**RE: DISAPPROVAL
RESPONSE TO DISAPPROVAL INVESTIGATION REPORT SOLID WASTE MANAGEMENT
UNITS (SWMU) NO. 4 OLD BURN PIT AND NO. 5 LANDFILL AREAS
WESTERN REFINING SOUTHWEST INC., GALLUP REFINERY
EPA ID # NMD000333211
HWB-WRG-17-006**

**RE: Response to Disapproval
Investigation Report Solid Waste Management Units (SWMU)
No. 4 Old Burn Pit and No. 5 Landfill Areas
Marathon Petroleum Company LP, Gallup Refinery
(dba Western Refining Southwest LLC)
EPA ID# NMD000333211
HWB-WRG-17-006**

**RE: Response to Disapproval
Response to Disapproval Investigation Report Solid Waste Management Units
(SWMU)
No. 4 Old Burn Pit and No. 5 Landfill Areas
Marathon Petroleum Company LP, Gallup Refinery
(dba Western Refining Southwest LLC)
EPA ID# NMD000333211
HWB-WRG-17-006**

**RE: DISAPPROVAL
RESPONSE TO DISAPPROVAL, RESPONSE TO DISAPPROVAL INVESTIGATION REPORT
SOLID WASTE MANAGEMENT UNITS (SWMU) NO. 4 OLD BURN PIT AND NO. 5
LANDFILL AREAS [DATED JULY 7, 2021]
RESPONSE TO DISAPPROVAL INVESTIGATION REPORT SOLID WASTE MANAGEMENT
UNITS (SWMU) NO. 4 OLD BURN PIT AND NO. 5 LANDFILL AREAS [DATED JUNE 30,
2021]
WESTERN REFINING SOUTHWEST INC., GALLUP REFINERY
EPA ID # NMD000333211
HWB-WRG-17-006**

FIGURE 2
SWMUs No. 4 & No. 5 LOCATION MAP
GALLUP REFINERY

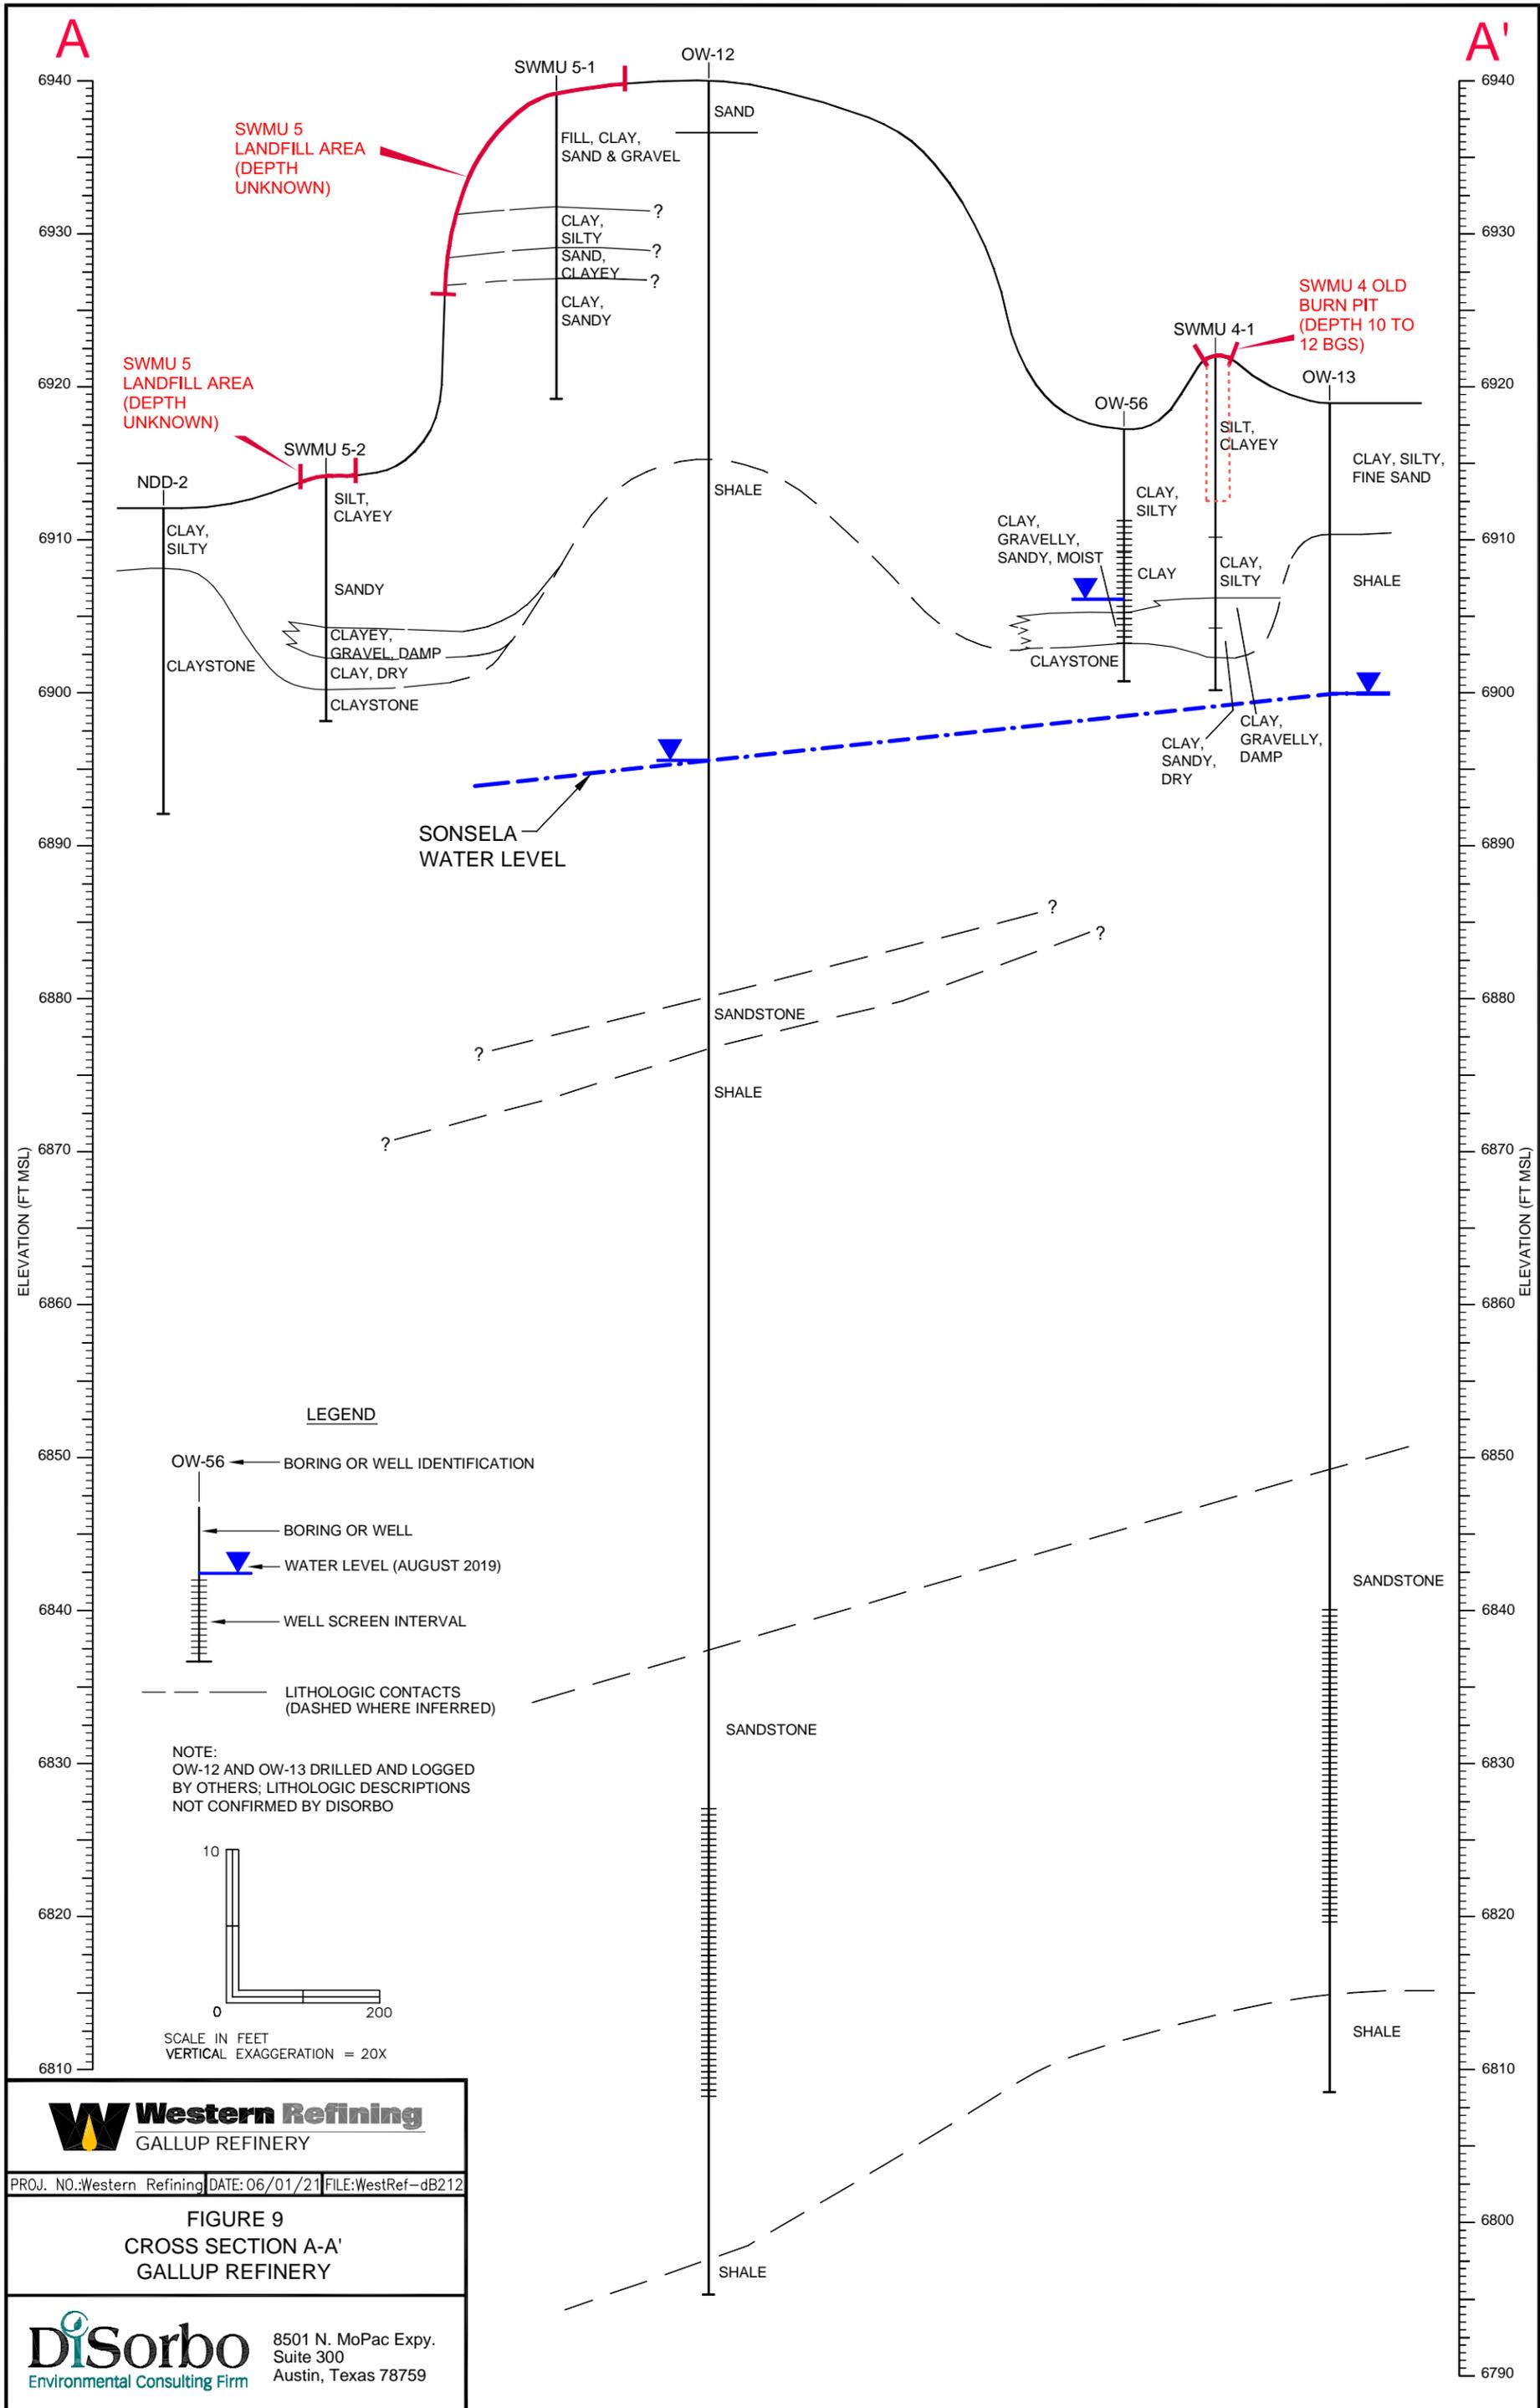
2. Figure 2 (SWMUs No. 4 & No. 5 Location Map) depicts the locations of the SWMUs, soil borings, a monitoring well (OW-56), a temporary monitoring well (NDD-2), and a cross-section A-A'. The Permittee did not include a boring log or well construction diagram for monitoring well OW-56 in the Report. However, Figure 9 (Cross Section A-A') includes a legend depicting monitoring well OW-56 that shows a general well diagram and lithologic information is included within the cross-section. The cross-section does not indicate saturation, but the lithologic information included for well OW-56 describes an interval from 6906 to 6904 ft msl as “clay, gravelly, sandy, moist”. Additionally, “damp” intervals were encountered in borings SWMU 5-2 and boring SWMU 4-1 at similar intervals to the moist interval in well OW-56. The Permittee must discuss site-specific groundwater in Section 4.2 (Subsurface Conditions) and discuss the presence of intermittent saturation. As the Permittee is aware, tight clays often prevent timely recharge within borings and wells, so the presence of groundwater may not be immediately observed.

3. Other than well OW-56 and NDD-2, the closest monitoring wells are OW-12 to the south and OW-13 to the east (not depicted on the figures in the Report). These wells monitor the Sonsela aquifer with depths to water at 47.23 ft bgs and approximately 21.5 ft bgs, respectively. There may be water present within the Chinle/Alluvium interface, as recorded in other areas of the refinery, but the boring logs for OW-12 and OW-13 are not detailed enough to determine if saturated intervals were encountered in these wells. Also, because of the difference in reporting the elevation of the subsurface data (ft msl in the Report versus feet bgs on the OW-12 and OW-13 well logs), it is difficult to determine whether the saturated intervals in the OW-12 and OW-13 wells can be correlated to the moist and damp intervals in the monitoring well and borings installed as part of the investigation.

4. Figure 2 has been revised to show the locations of OW-12 and OW-13 and Figure 9 presents a revised cross section; these figures are provided in the revised Investigation Report. The boring log for OW-56 has been included in Appendix D of the revised Investigation Report. In response to NMED’s comment regarding site-specific data, Section 4.2.2 (Hydrogeology) page 4-4 has been revised to state:

WELL NO. OW-56

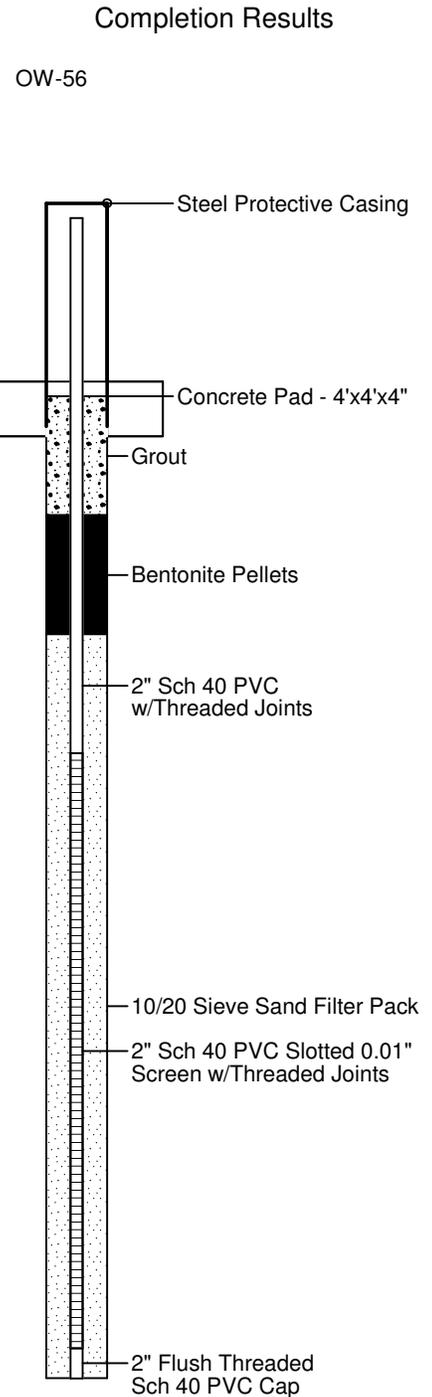
In addition, the historical groundwater measurement data indicates that shallow groundwater is consistently detected in wells OW-56 and OW-62; therefore, shallow groundwater may be present regularly rather than sporadically in the SWMUs 4 and 5 areas. Correct the statement in the revised Report, as appropriate.

FIGURE 1

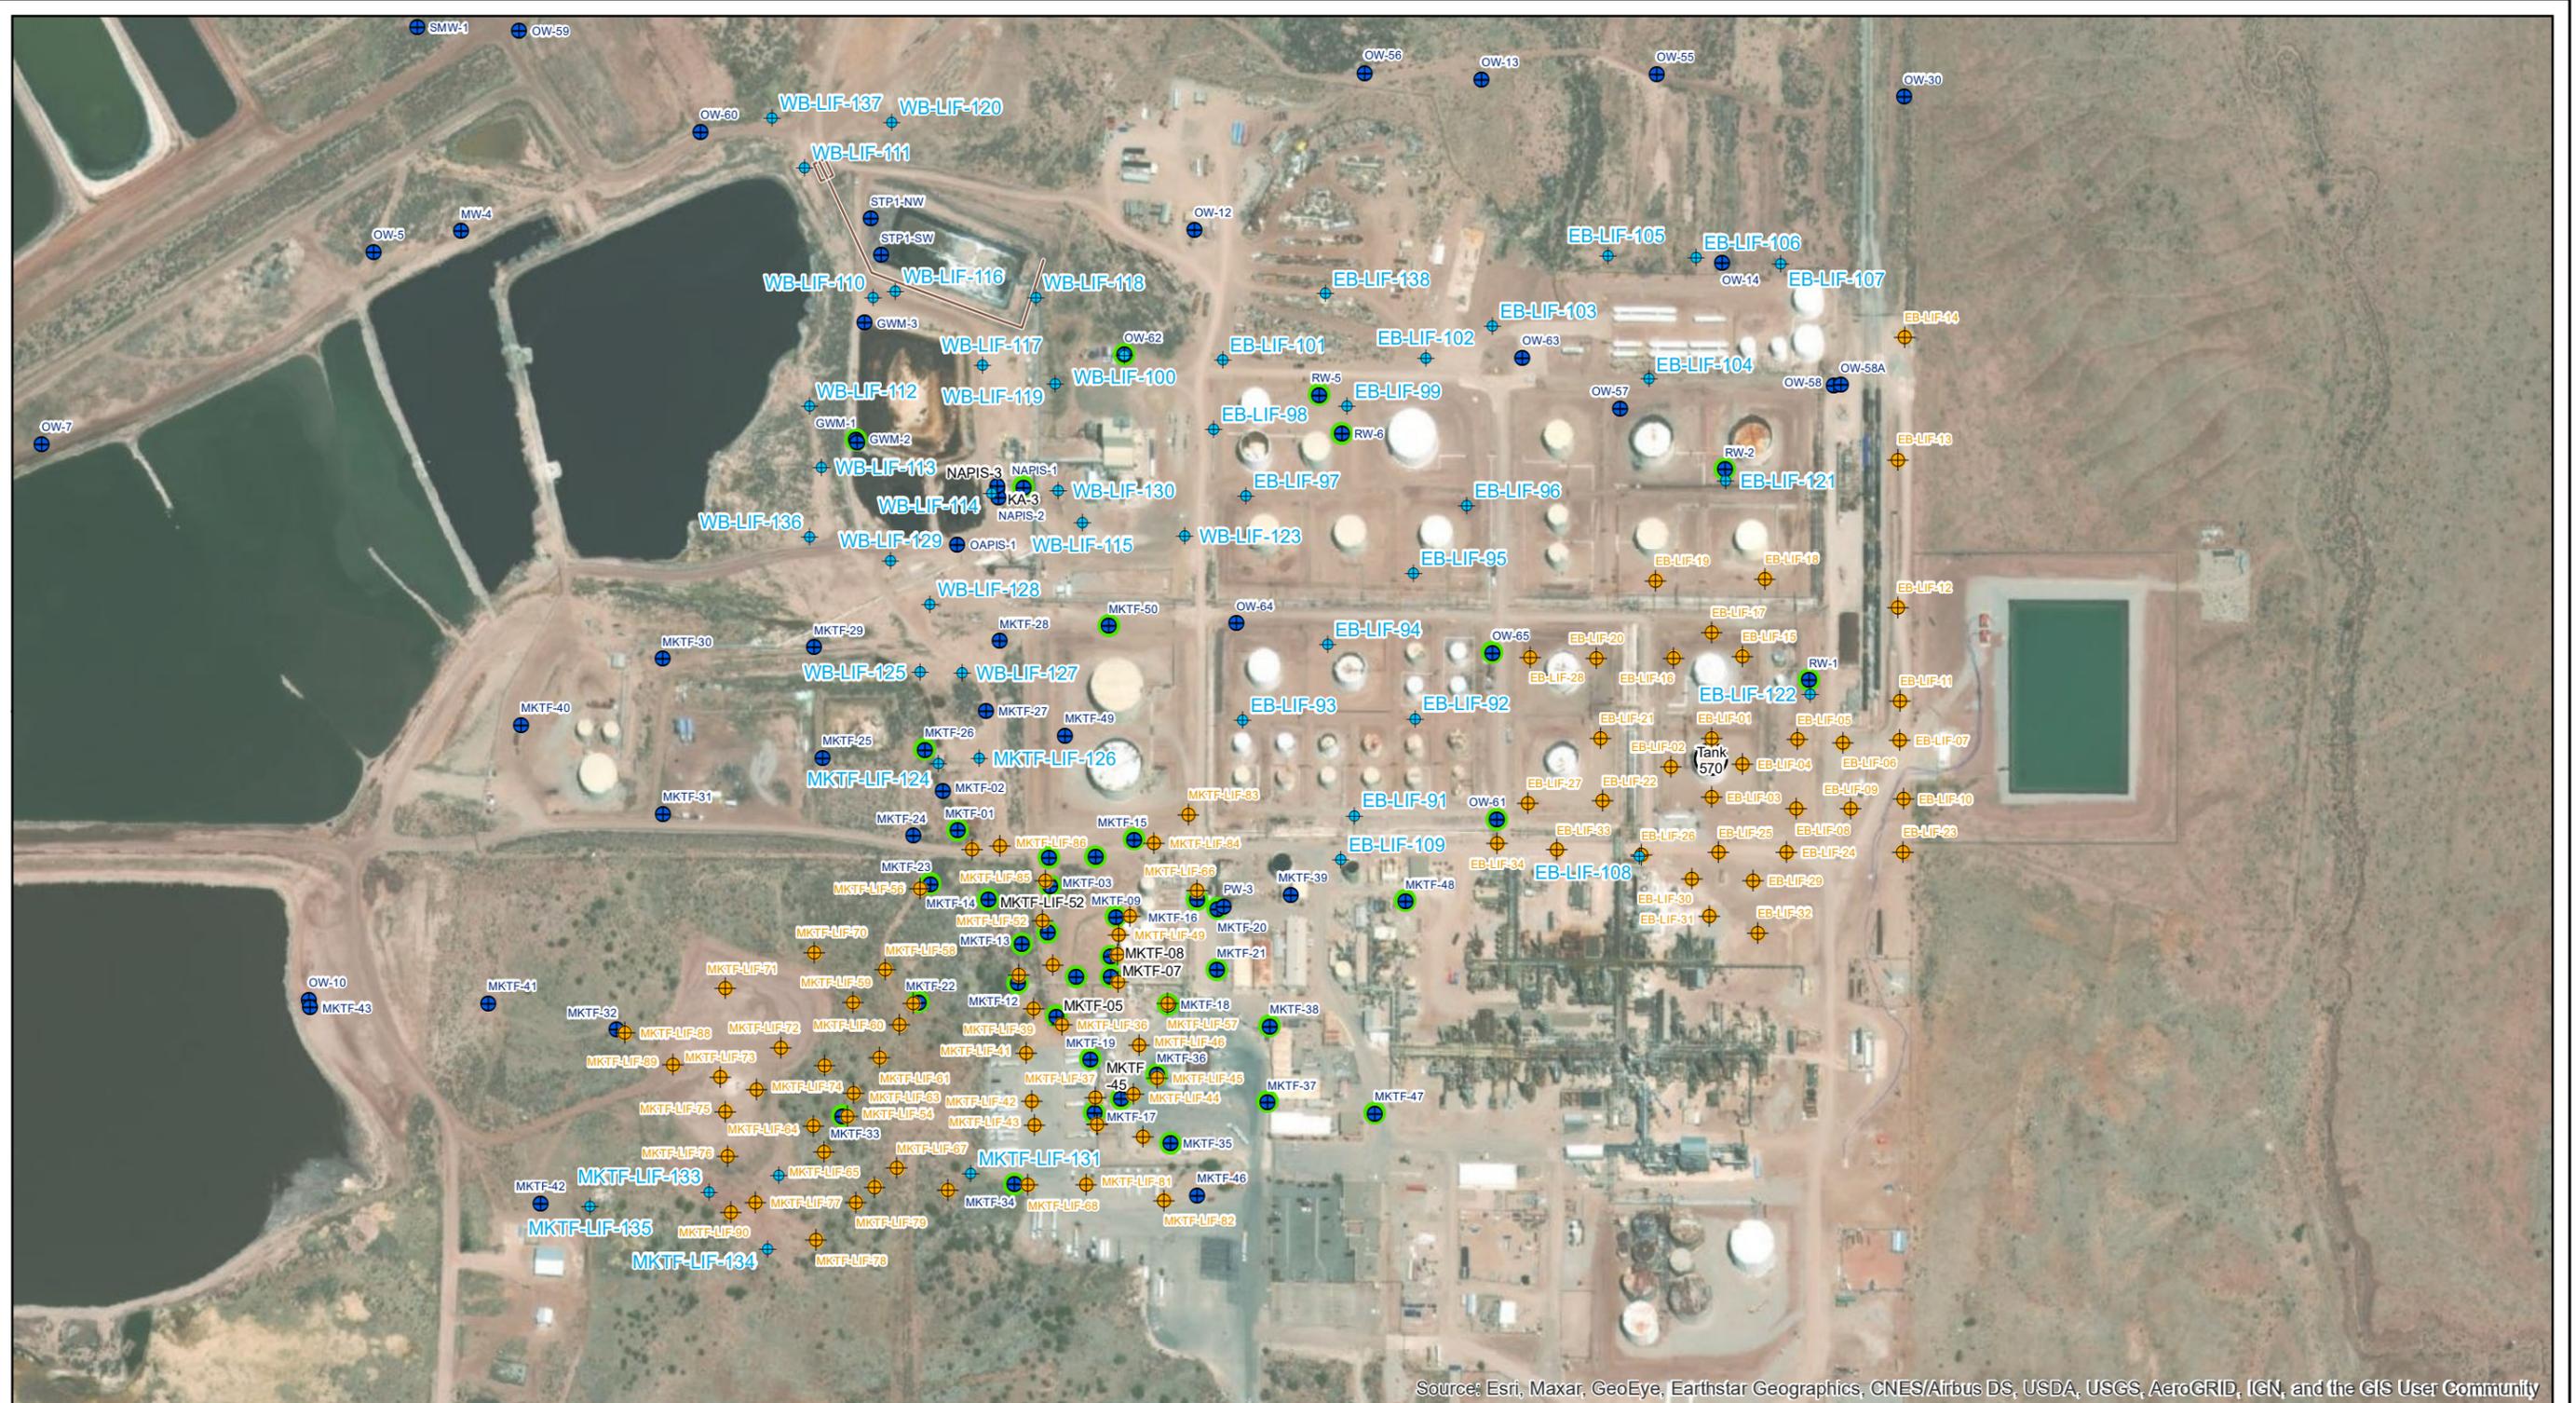
According to Figure 1, the locations of the LIF borings are shown; however, the boundaries of SWMUs 4 and 5 are not identified. Therefore, it is not clear how the LIF borings are relevant to the investigation of SWMUs 4 and 5. The figure must be revised to identify the boundaries of SWMUs 4 and 5. Note that the LIF investigation results may be incorporated to assess the presence/absence of non-aqueous phase liquid (NAPL) in the SWMUs 4 and 5 areas; however, LIF data cannot be used to identify exceedance of the screening level for each individual constituent and cannot be used to demonstrate compliance. Accordingly, the LIF investigation results do not preclude the requirement for a recollection of the samples from the SWMUs 4 and 5 areas. Propose to collect additional soil/groundwater samples from SWMUs 4 and 5 to confirm that recent activities (e.g., releases) have not adversely affected the areas in the revised Report, as appropriate.
